# Plan Commission Staff Report

Re: Audubon Arboretum Subdivision Phase 1 – Final Plat

PEG JOB#957.00  
SHEET 2 OF 3

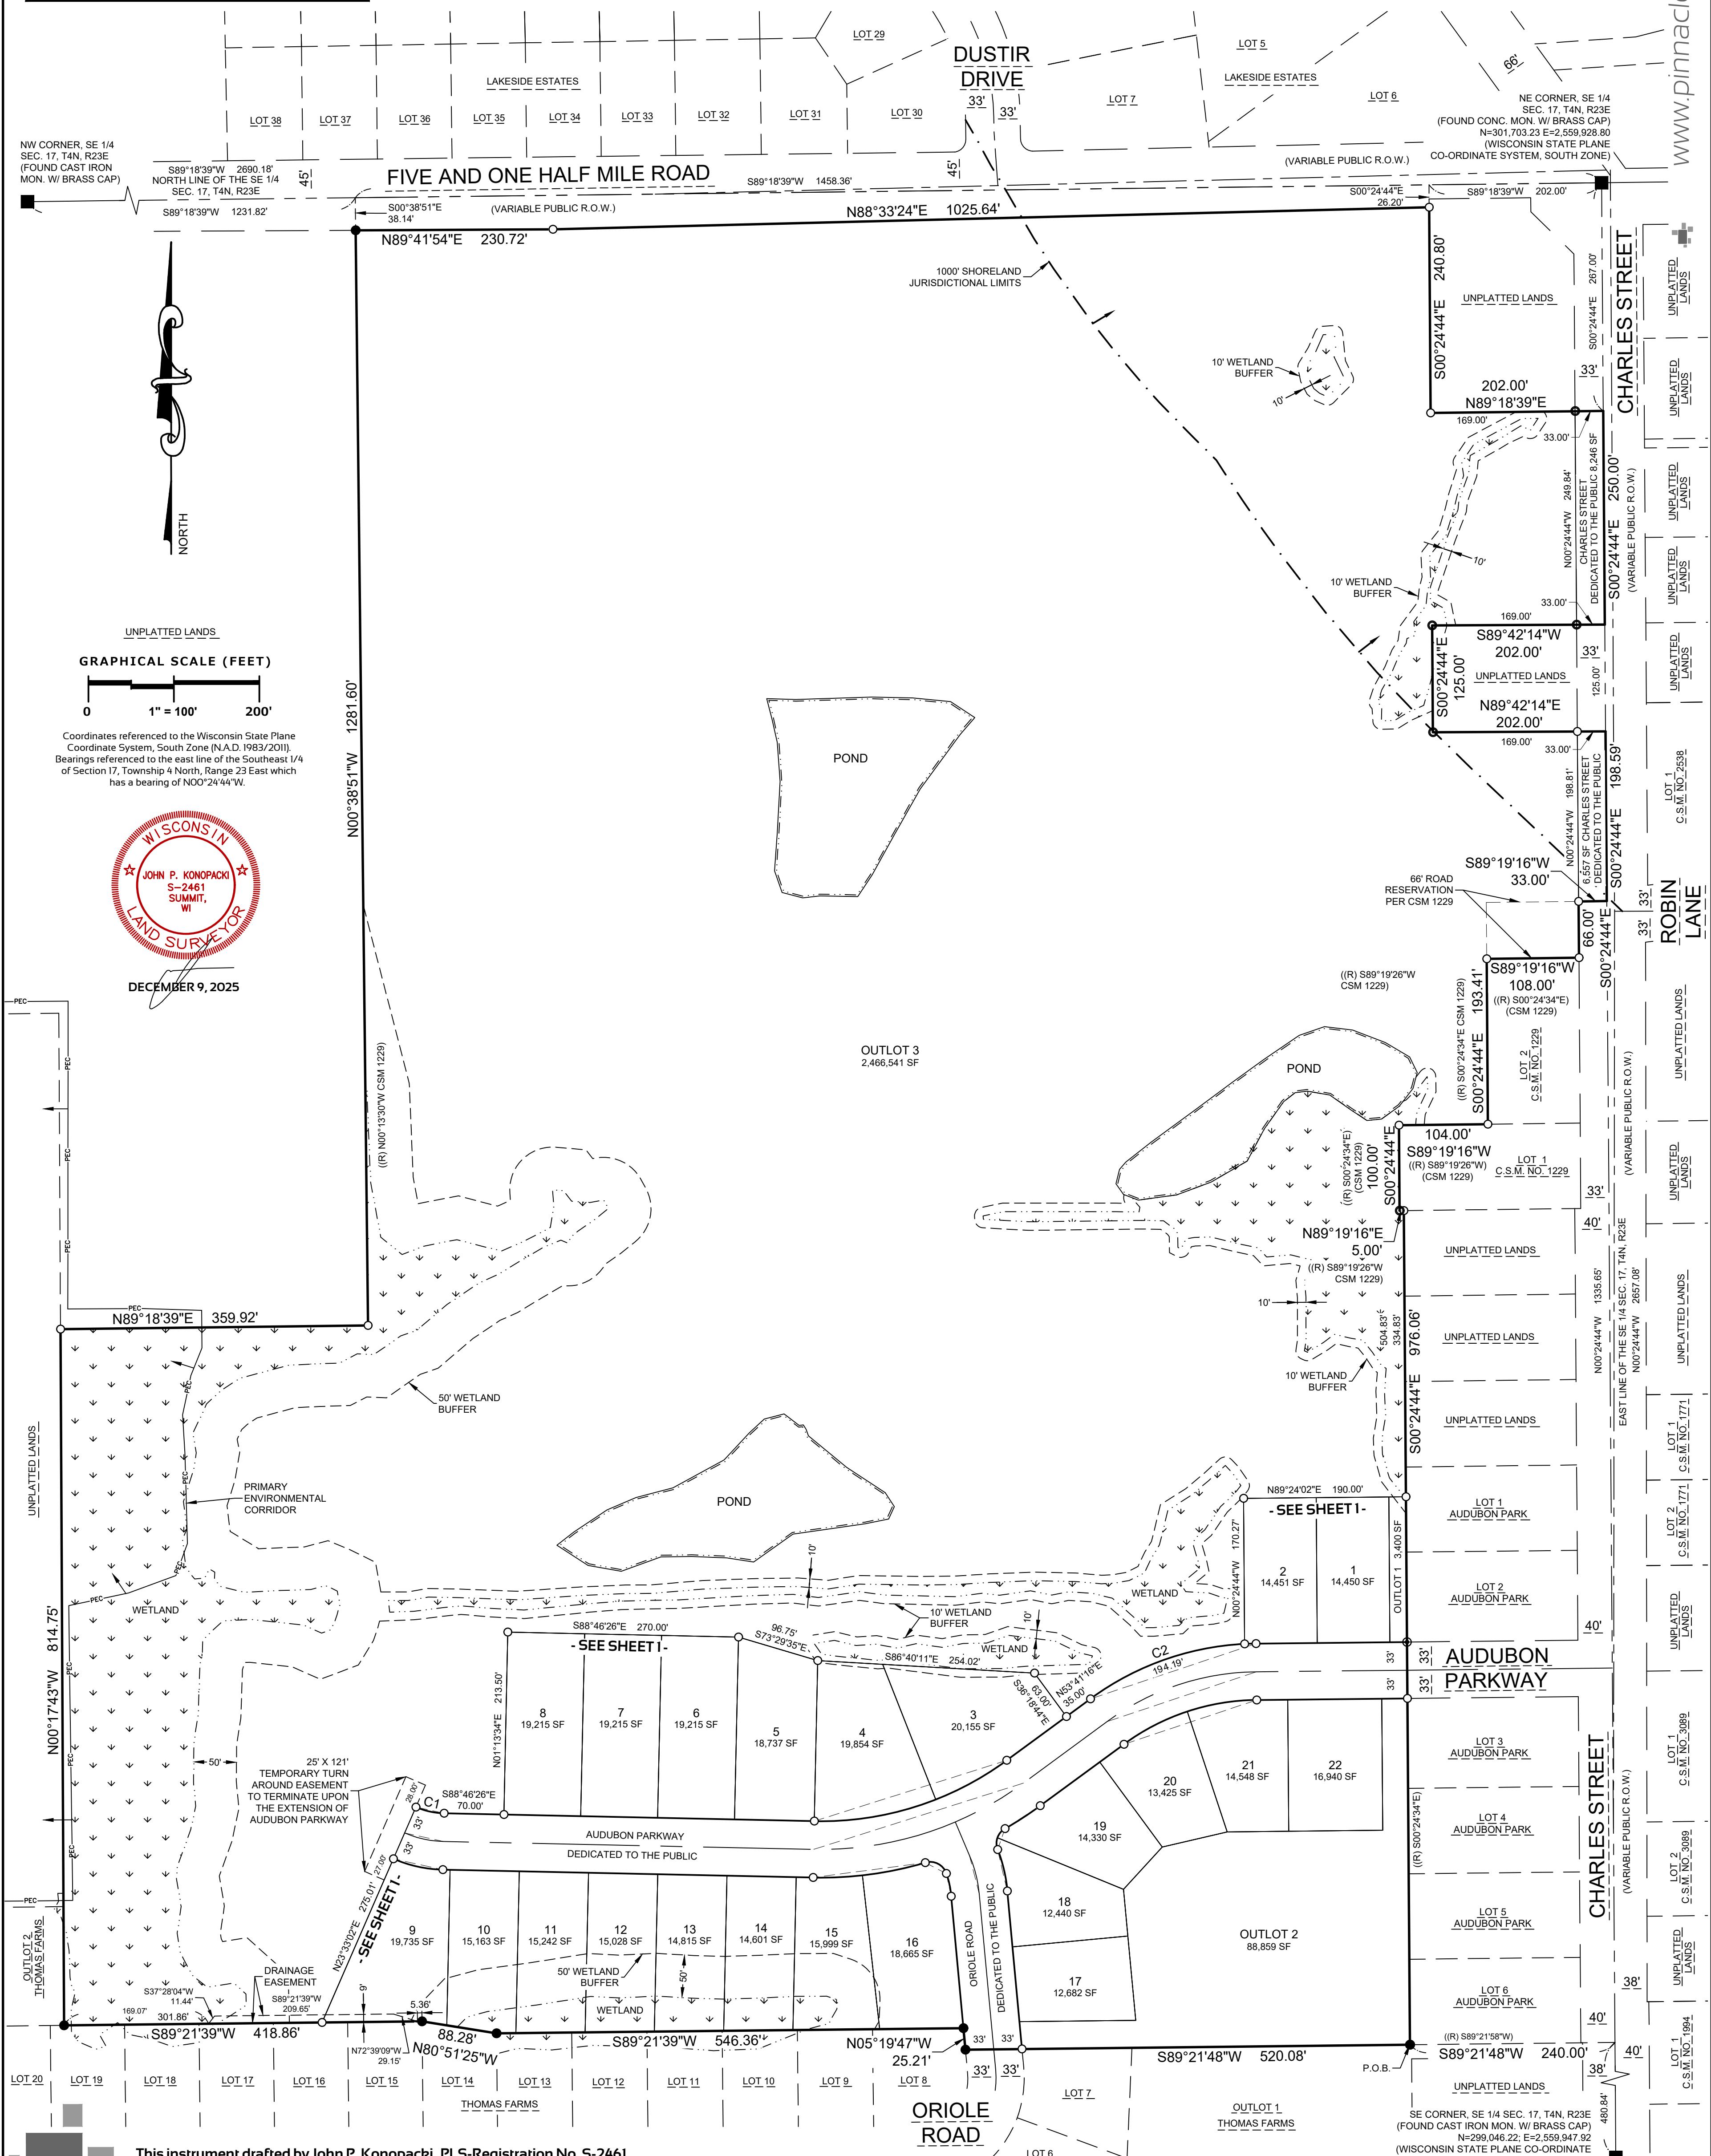
easements now compared with what was done in the past and are not needed on all lots, especially those that abut an Outlot. The temporary turnaround easement should be modified to a dimension of 33' x132' as is required by Village Standards.

A wetland delineation was performed in 2022 and included both the Audubon Arboretum and the proposed subdivision. Wetlands are shown on the Final Plat as required and a copy of the delineation is on file with the Village. The required buffers are shown and the new limits because of waivers. The varying buffers (10' and 50') shall be clarified in the notes of the Final Plat since there is only a description of the 50' buffer.

3. Correct the Temporary Turnaround Easement to be 33'x132' as required by Village Standards.
4. Remove the 12' Public Utility Easement on all lots other than what is required for rear yard drainage.

7. The Developer submits a draft set of restrictive covenants for the HOA for Staff and the Village Attorney to review.
8. The Surveyor updates the Final Plat to include language regarding the 10' wetland buffers in the Notes.
